Commonwealth Edison

August 23, 1983

Subject: LaSalle County Station Unit 2
Specific Requests for Unit 2
Technical Specifications
NRC Docket No. 50-374

SUBJECT: MCPR Operating Limit without EOC-RPT Unit 2 Technical Specification

Figure 3.2.3-1 Minimum Critical Power Ratio (MCPR) vs. AT

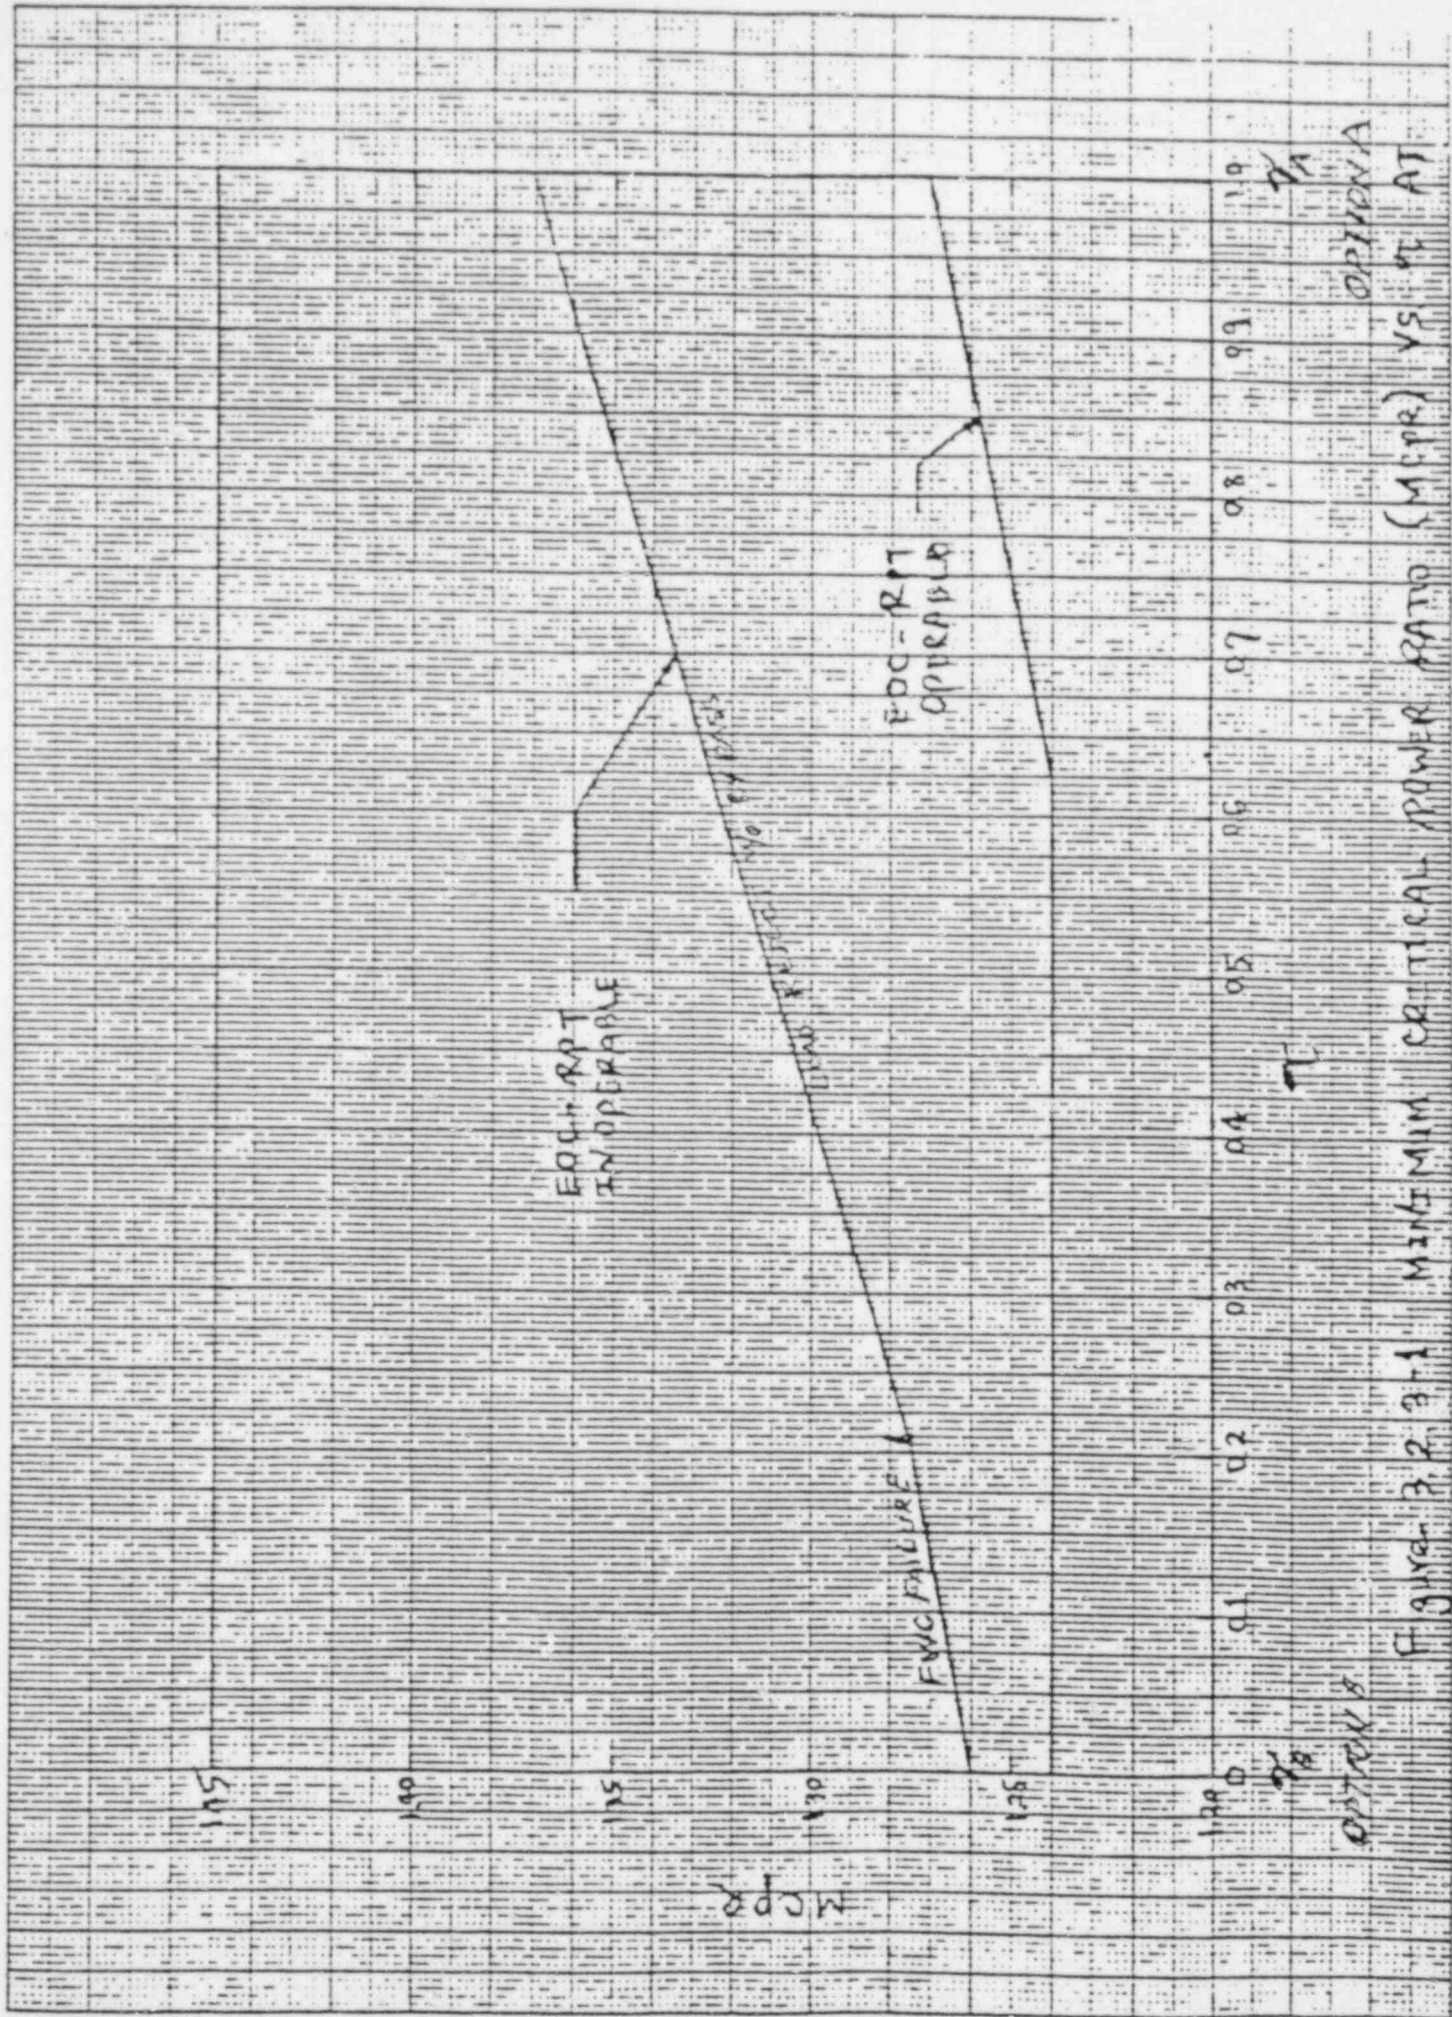
Per your request, the MCPR operating limit without EOC-RPT has been calculated for LaSalle Unit 1. The results of this evaluation are summarized below and on the attached graph. Please note that the load rejection without bypass transient sets the limit at Option A and the feedwater controller failure sets the limit at Option B. The limit at scram times between the two options must be determined from the graph.

Transient Event	MCPR-Operating Limit	
	Option A	Option B
Load Rejection without Bypass without EOC-RPT	1.37	1.25
Feedwater Controller Failure without EOC-RPT	1.33	1.26

- A. With the end-of-cycle recirculation pump trip system inoperable per Specification 3.3.4.2, operation may continue and the provisions of Specification 3.0.4 are not applicable provided that, within one hour, MCPR is determined to be equal to or greater than the MCPR limit shown in Figure 3.2.3-1 EOC-RPT inoperable curve, times the K_f shown in Figure 3.2.3-2.
- B. With MCPR less than the applicable MCPR limit shown in Figures 3.2.3-1 and 3.2.3-2, initiate corrective action within 15 minutes and restore MCPR to within the required limit within 2 hours or reduce THERMAL POWER to less than 25% of RATED THERMAL POWER within the next 4 hours.

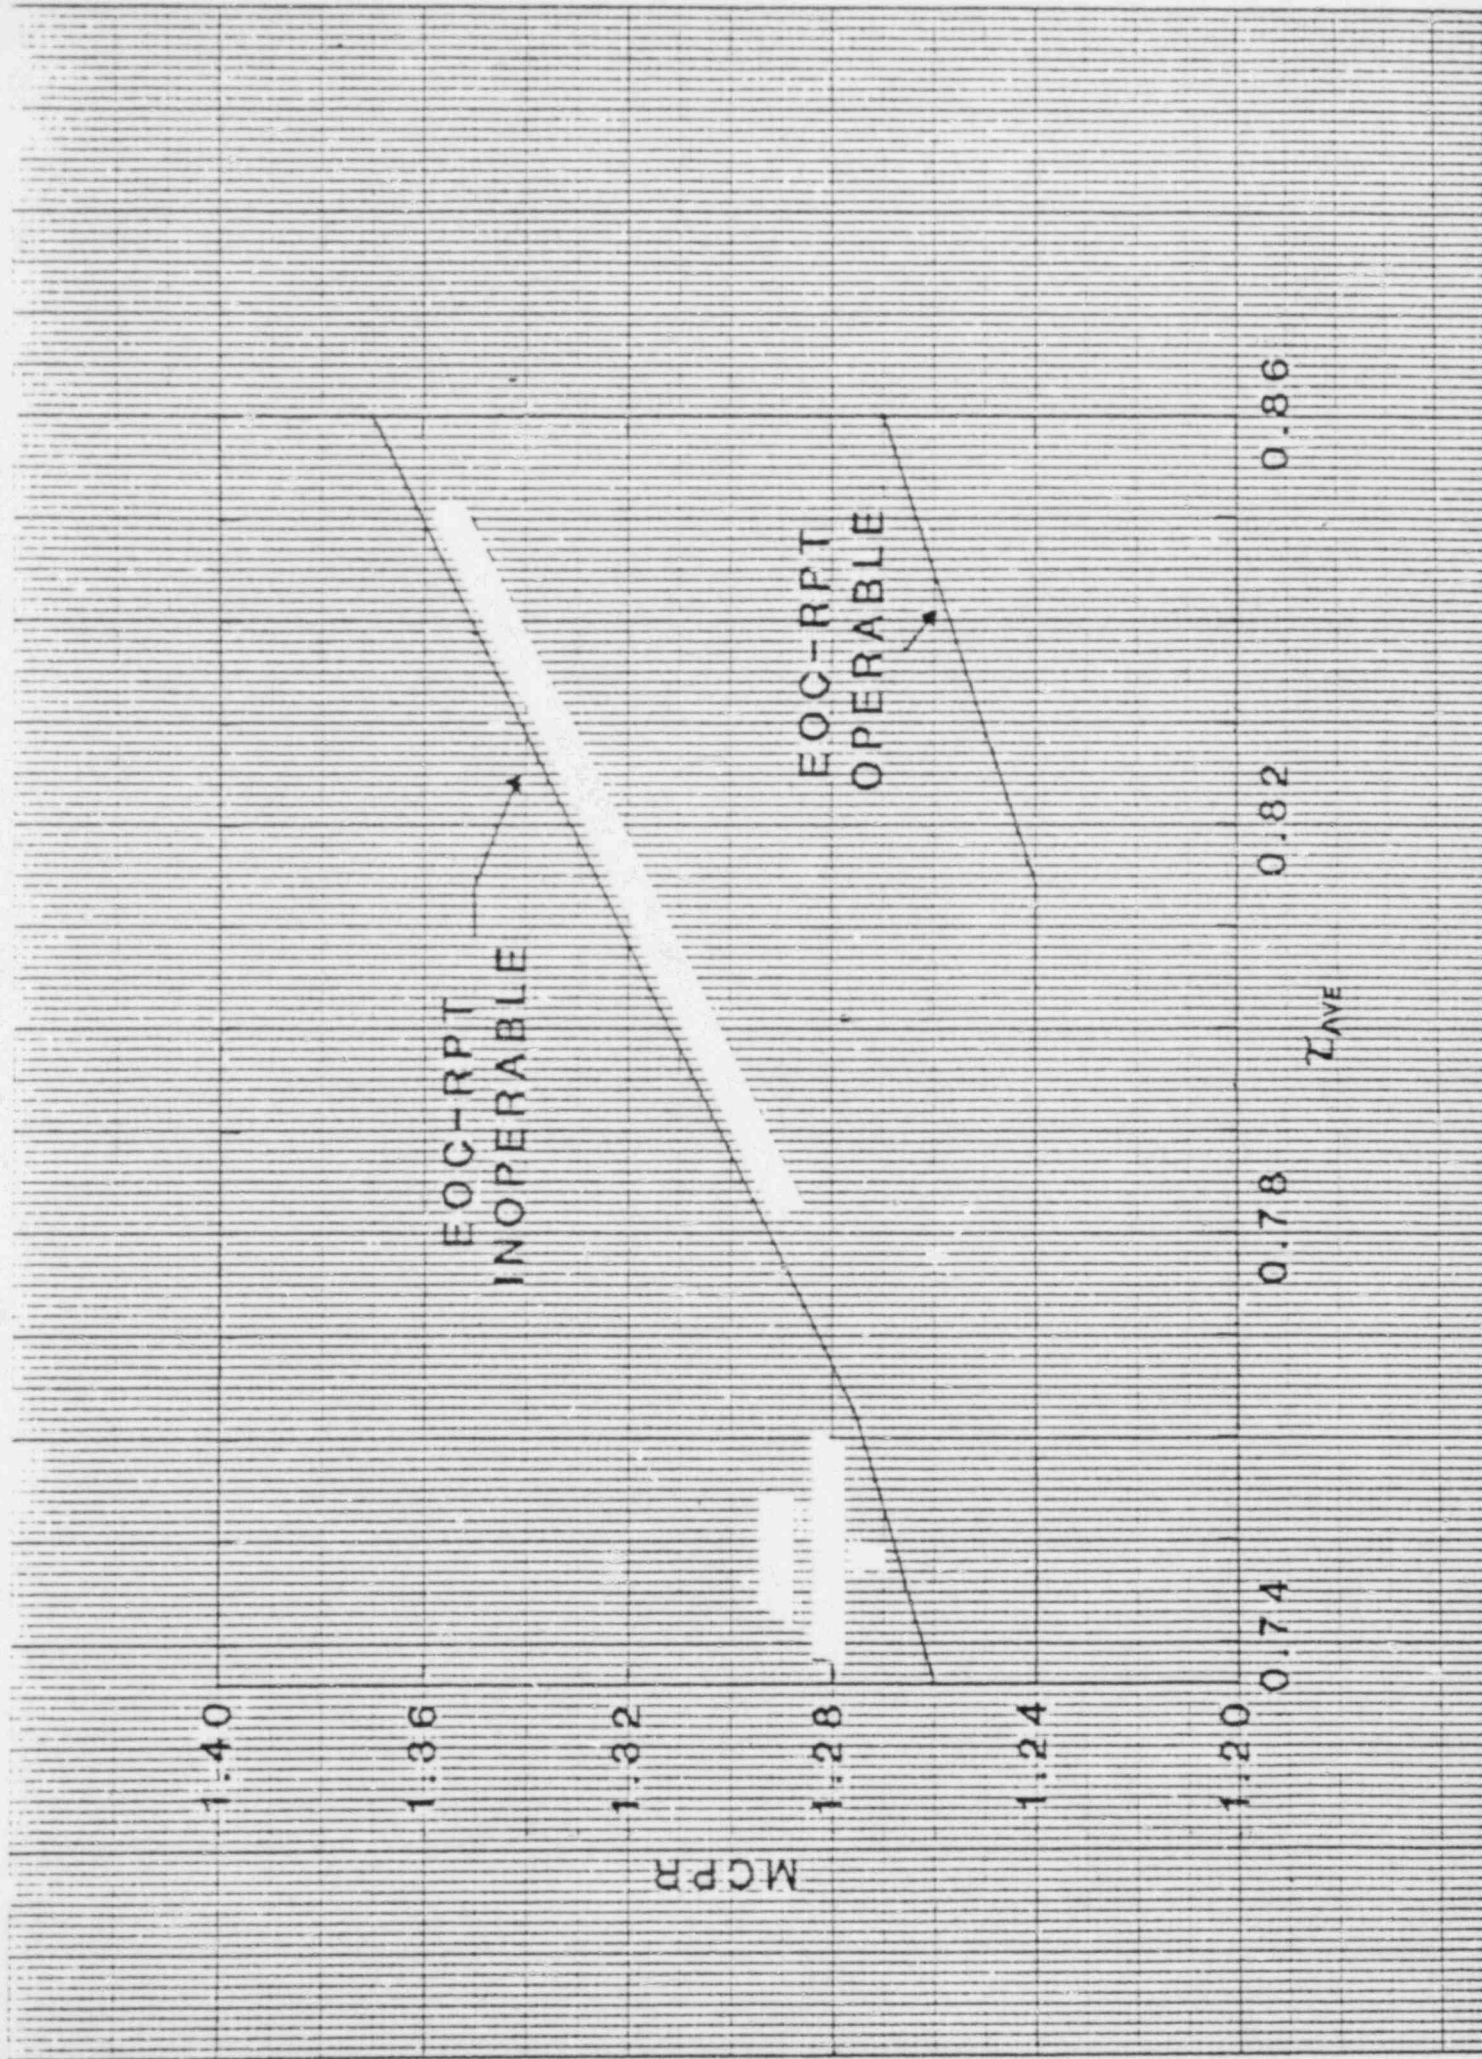
3.2.3 The MINIMUM CRITICAL POWER RATIO (MCPR) shall be equal to or greater than the MCPR limit determined from Figure 3.2.3-1 times the K_f determined from Figure 3.2.3-2, *provided that the LFC-EPT system is operable per Specification 3.3.4.2.*
APPLICABILITY:

insert attached
With MCPR less than the applicable MCPR limit determined from Figures 3.2.3-1 and 3.2.3-2, initiate corrective action within 15 minutes and restore MCPR to within the required limit within 2 hours or reduce THERMAL POWER to less than 25% of RATED THERMAL POWER within the next 4 hours.
